Comments on the HHH Project by Dave Sharp

The ASC Section 2.3 Construction on Site

¹Kiona Ridge Screenshot with Turbine Locations-Satellite View-Exhibit 1

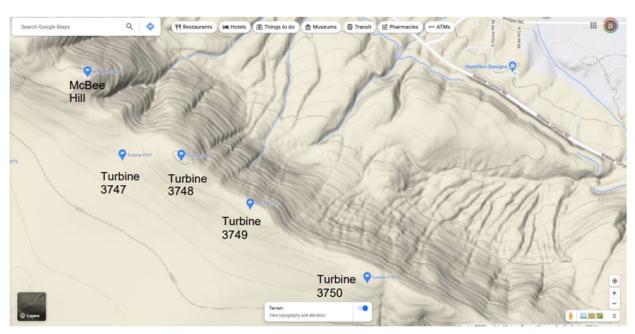
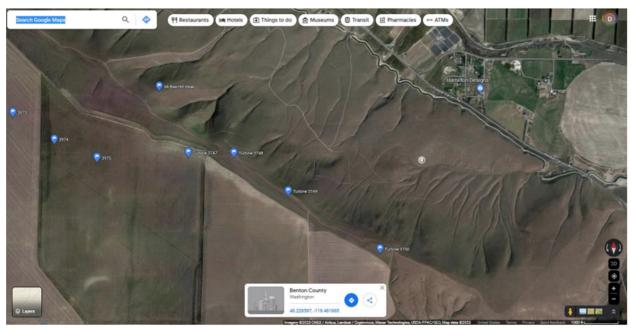
- **Q.** Why are you adding this testimony at this time rather than during public comment period?
- A. The Applicant all through the public comment period did not disclose coordinate locations of the turbines, and the documentation provided with the project did not allow positively locating the turbines. After the comment period had passed for the Application, documentation was posted to the EFSEC website in the form of Department of Defense Contractual Agreements¹ that showed number and coordinate

locations of the turbines. The first time those locations became publicly available was after the Draft EIS public comment was closed. And during the site tour, the Applicant stated they were not on the ridgeline.

- ¹ 20230120_DODMitAgrmnt_Amended.pdf (wa.gov)
- **Q.** Could you describe the results of your review of those coordinate locations?
- A. First, I took the coordinates from the posted documentation from the EFSEC website and inserted the coordinates on Google Maps. Each label designates a turbine location. I was surprised that the several of the turbines were located at the crest of the Kiona Ridge^{2 and 2A}, and located **on the existing trail**. Another turbine is 400-500 feet from the trail. This conclusively puts the location of the turbines in an area regularly used by people. To say nothing about the loss of recreational experience, any type of operational incident could have deadly consequences directly under the turbines and also downwind to the North (prevailing winds).
